# Mask Set Errata for Mask 0L47P

This mask set errata applies to the mask 0L47P for these products:

- MC68HC908AP64
- MC68HC908AP32
- MC68HC908AP16
- MC68HC908AP8

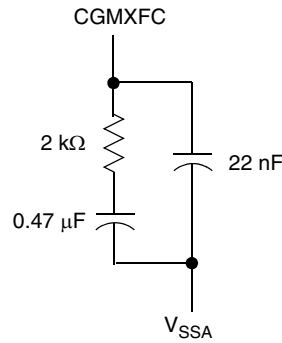
Do not use the PLL under these settings:  $AUTO = 1$ ; or  $AUTO = 0$  and  $\overline{ACQ} = 1$ .

The clock generator module's PLL does not meet stability requirements when running in automatic bandwidth control mode or manual tracking mode. In these modes, the VCO output clock can become erratic, causing unpredictable MCU clocks, and resulting in possible MCU failure.

To overcome this problem, the PLL must be used in manual acquisition mode ( $AUTO = 0$  and  $\overline{ACQ} = 0$ ). As a result, there is no PLL lock detector, nor lock interrupt. The LOCK and PLLF bits are meaningless.

1. Use the following external filter components:

2. Configure the PLL to the desired frequency.
3. Clear AUTO and  $\overline{ACQ}$  bits.
4. Set PLLON bit to turn on the PLL.
5. Wait 50ms for the PLL to lock.
6. Set BCS bit to select the VCO clock as the reference clock for the MCU.

Figure 1. Typical ADC Error Count

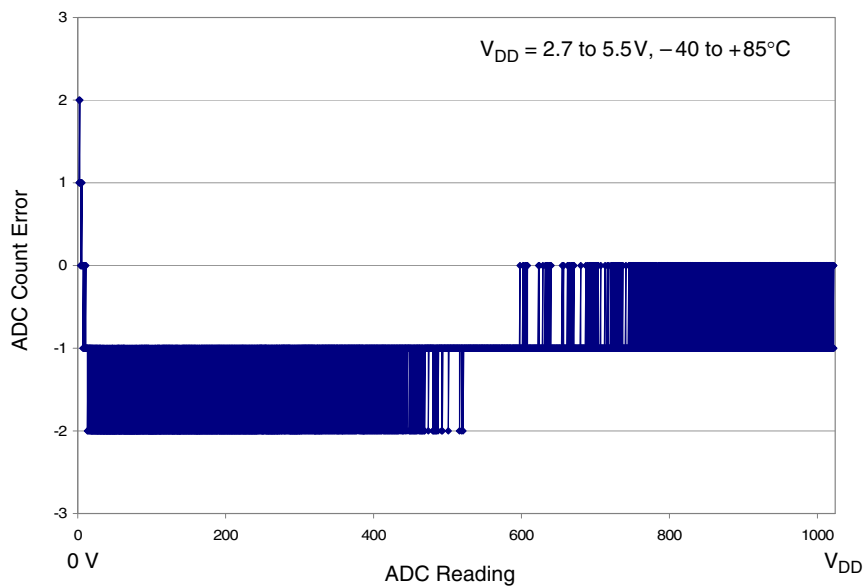
The 10-bit ADC conversion result for 0V input (zero input reading) is \$000, \$001, \$002, or \$003; not the specified \$00 or \$01. With inputs of 5mV and above, the ADC is within the specified accuracy of  $\pm 1.5$  LSB (see [Figure 1](#)).
